**MELBOURNE METRO EES INQUIRY**

*PROPOSED MELBOURNE METRO  
DOMAIN STATION  
ASSESSMENT OF AIR QUALITY  
ISSUES*

Prepared for Owners Corporation 348427V of 400  
St Kilda Road, Melbourne (“The Botanica”)

**12 August 2016**

**Fig 1. Domain Station precinct (based on Figure 6-9 of the EES) showing extent of construction activities and the Botanica site (in red)**

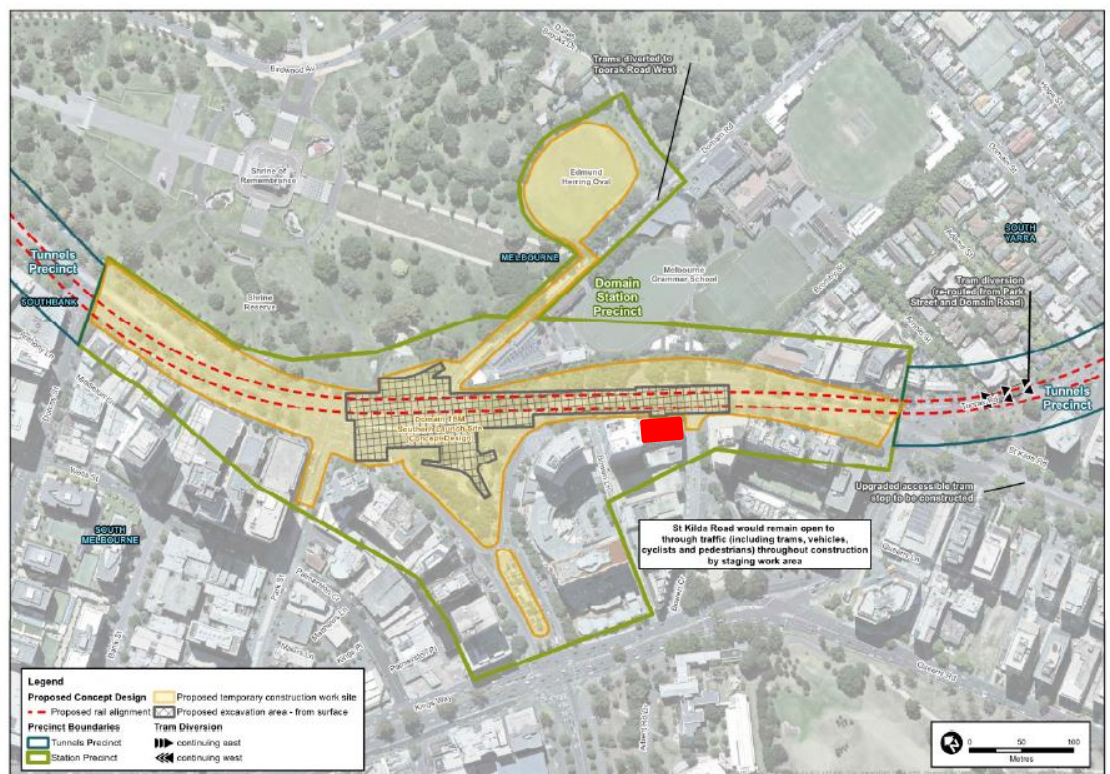
The Botanica apartments will be particularly sensitive to an increase in local dust levels, because I understand that all of the apartments facing St Kilda Road and Bowen Crescent (and most of the others) have doors opening onto balconies, openable windows and most have individual “split” air conditioning systems (the only way to introduce fresh air into the apartments is by opening external doors and/or windows).

Figure 7-8: Conceptual site model for the tunnels area between CBD South and Domain stations

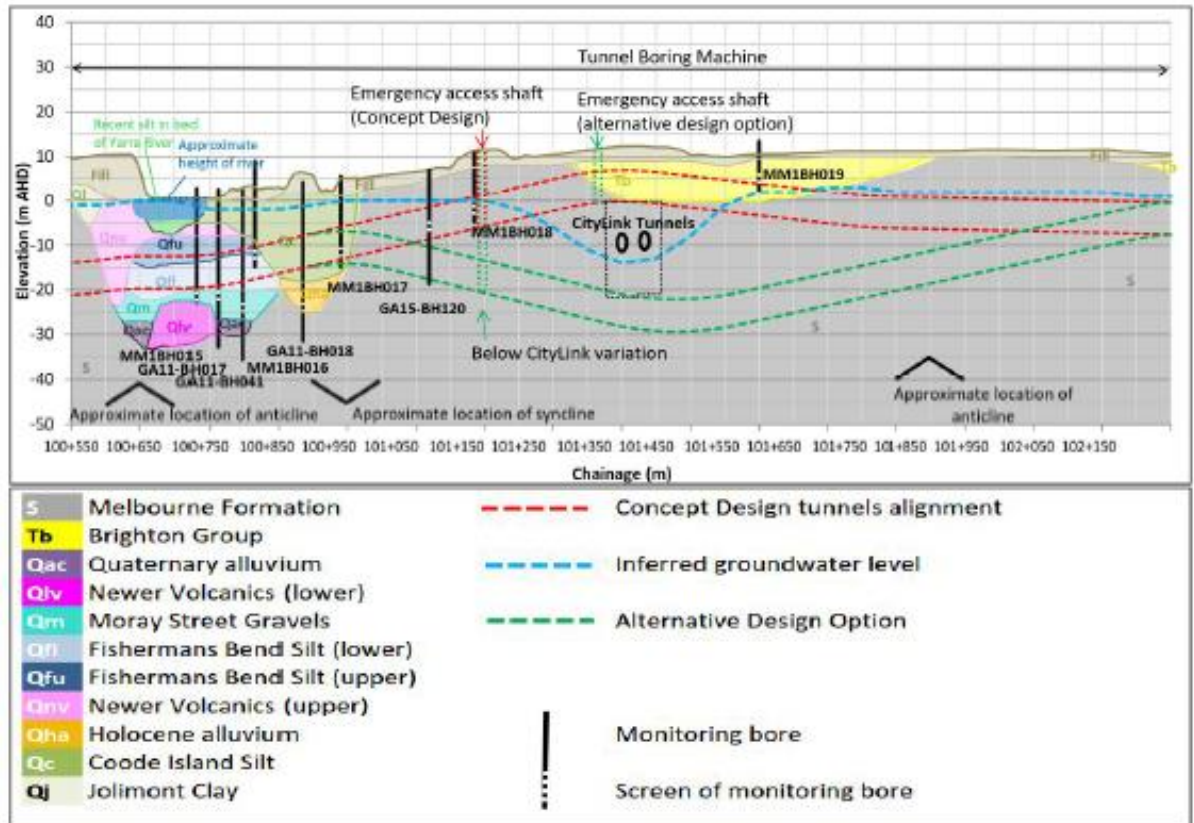
Figure 7-8 indicates that these tunnels will be bored predominantly through the Melbourne Formation. The “Concept Design” tunnels will be above the watertable in the vicinity of the CityLink tunnels (which result in a drawdown of the watertable). In contrast, the “Alternative Design Option” alignment, which passes under the CityLink tunnels, is below the watertable.

Figure 7-10: Conceptual site model for the tunnels area between Domain station and the eastern portal

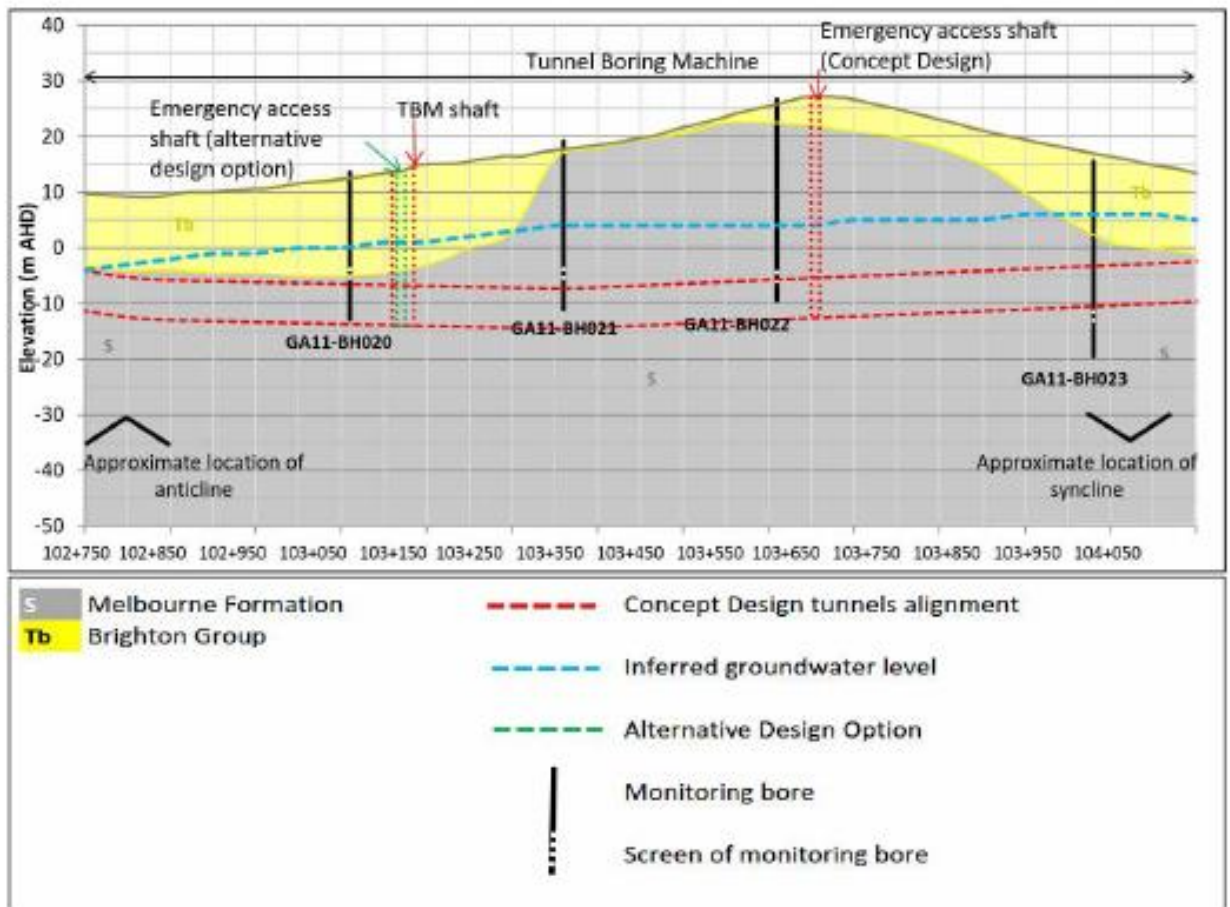
Figure 7-10 indicates that these tunnels will be bored entirely through the Melbourne Formation and below the watertable.

Figure 7-10 indicates that the (unsaturated) Brighton Group overlies the Melbourne Formation in the vicinity of Domain Station and that the (approximately 19 m deep) excavation for the station will penetrate about 10 m into the Melbourne Formation. There is a significant drawdown of the water table in this location (as a result of infiltration of groundwater into the South Yarra Main Sewer), which suggests that the majority of the Melbourne Formation to be excavated to form the “station box” will be above the water table.
